Final Program Environmental Assessment for Proposed Amended Regulation XX – Regional Clean Air Incentives Market (RECLAIM)

November 2015

SCAQMD No. 12052014BAR
State Clearinghouse No: 2014121018

Figure 3: Site Plan

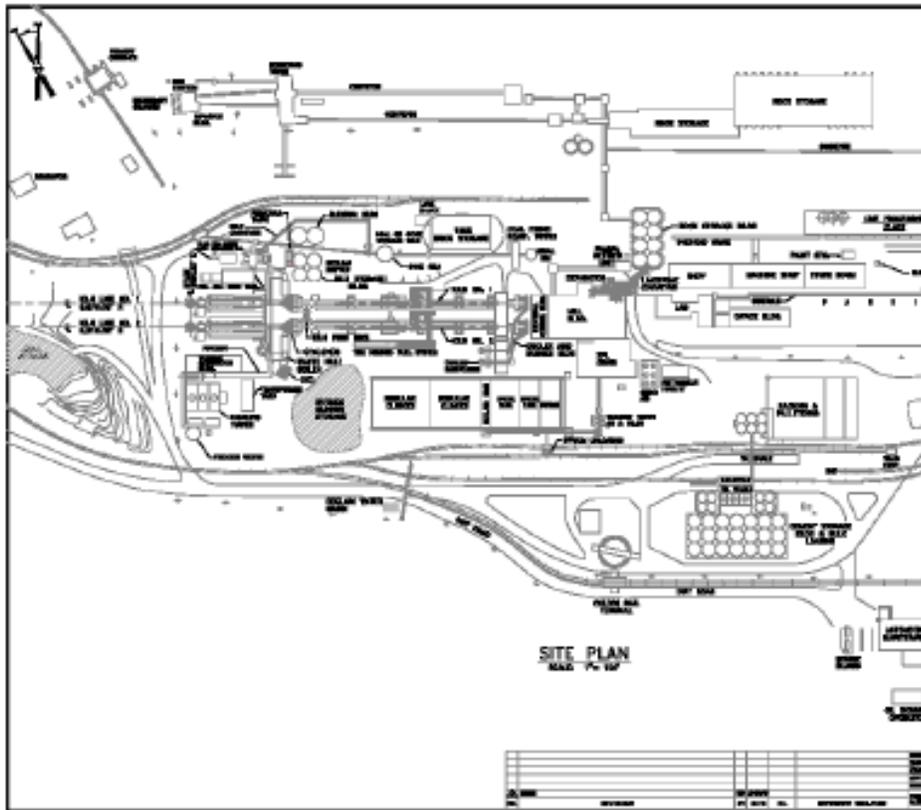
Vendor 1 proposed to install a SCR between the waste heat boiler and the baghouse. In reality, the SCR would not physically be located between the waste heat boiler and the baghouse as there is physically no room to install an SCR there on either kiln. Figure 2 is a photograph of the kiln baghouses and stacks and illustrates the physical constraints and physical size of the equipment.

Figure 3 above shows the existing equipment at the site. As is obvious from the site plan and the photo in Figure 2, the SCRs cannot physically be located between the waste heat boilers and the baghouses. The existing coal pile and handling systems are north of the baghouses and cannot be moved due to fugitive emissions constraints as well as proximity to coal unloading and handling equipment. Therefore, the SCRs would need to be located in the area north of the kilns, Co-generation facility or rail lines, requiring the ductwork to go above existing equipment 150-200 feet to the SCR and then back 150 -200 feet to the baghouse inlets. This ductwork would need to be insulated and the SCR and ductwork construction would need to comply with local seismic construction codes. As noted in the initial summary, CalPortland has been denied access to the vendor design basis based on confidentiality of the vendor information and the cost spreadsheets provided on January 23, 2015 do not contain sufficient detail to make a determination. Therefore, it is unknown whether the increased construction costs, potentially 20% or more, to comply with local seismic codes were included in their cost estimates.

Figure 6: Vendor 3 Proposed Control Gas Flow System

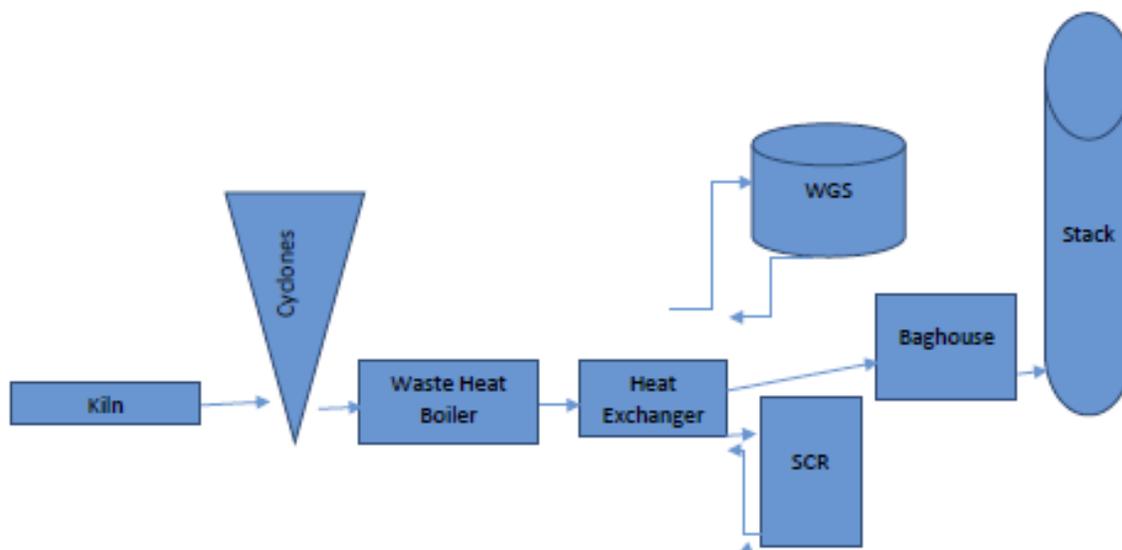
The Ultracat ceramic filter system is untried on a full-scale long-term application for a cement kiln. Given the differences in cement plant applications compared to other applications, CalPortland does not believe that it meets the criteria for a demonstrated control technology for this application especially for a definition of a best available "retrofit" technology. Further, although the vendor literature indicates that their product will control particulate emissions to levels that comply with the 40 CFR Part 63, Subpart LLL (the NESHAPS for portland cement manufacturing), CalPortland is unaware of any long-term application of the technology on a cement kiln and cannot verify that it will comply with the new emissions limitations for PM in routine cement application.

Vendor 3 proposes to utilize a wet gas scrubber to address the SO₂ in the gas exiting the waste heat boilers, a heat exchanger to increase the gas temperature for the SCR and then replace the existing baghouse. Figure 6 below illustrates the kiln gas flow through this control system.
